Limited Visual Dam Safety Inspection Summary Report

MA-139

Maui Field 290 Reservoir

Limited Visual Dam Safety Inspection Conducted on: 07 April 2006

139 Downstream slope and cover - View of DS slope angle and heavy brush and tall grass cover.

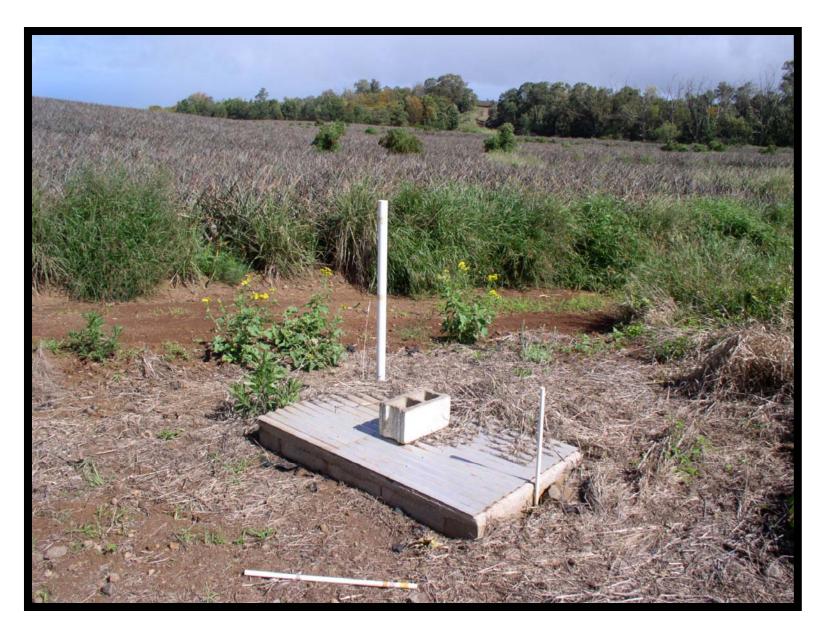
- a. The downstream slope appeared to be in fair to poor condition and requires corrective action.
- b. The down stream slope was not visible due to high grass and bush vegetation. Clear high vegetation and maintain low to enable easy visual inspection.

Heavy growth needs to be removed from the downstream slope to promote visual inspection of slopes.
